**Re: Crystal Springs Water District (PWS ID #00386)
 West Side Reservoir & Waterlines Phase 2 (PACE Project #17816)
 Conditional Approval – Plan Review #55-2020**

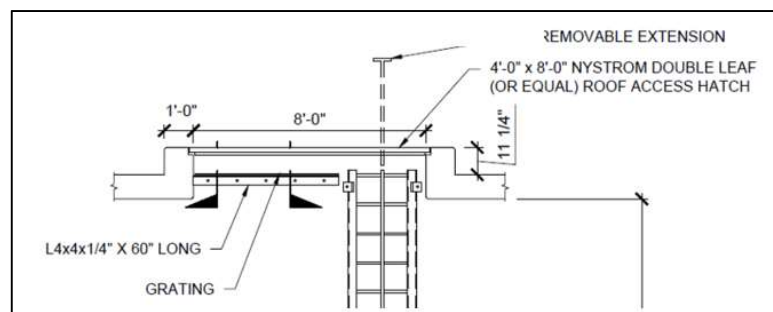
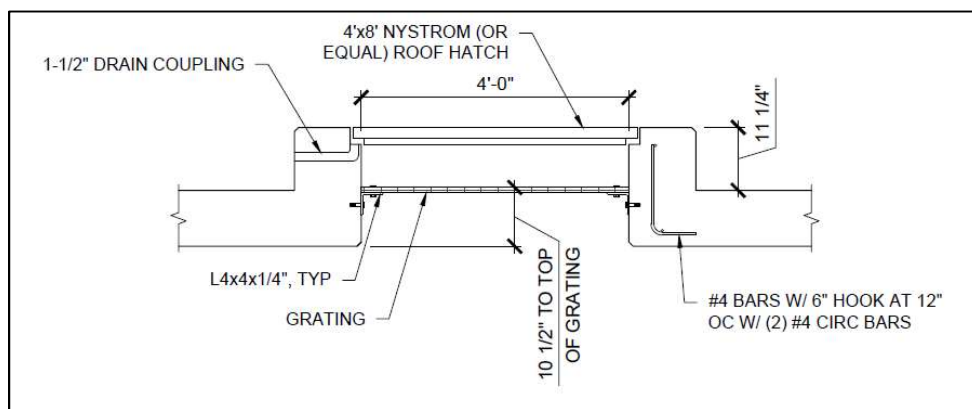
1. An access manhole shall be provided to permit entry to the interior for cleaning and maintenance. When the access manhole is on the roof of the reservoir there shall be a curbing around the opening and a lockable, watertight cover that overlaps the curbing [OAR 333-061-0050(6)(J)]. The proposed hatch does not appear to meet this requirement as shown below:
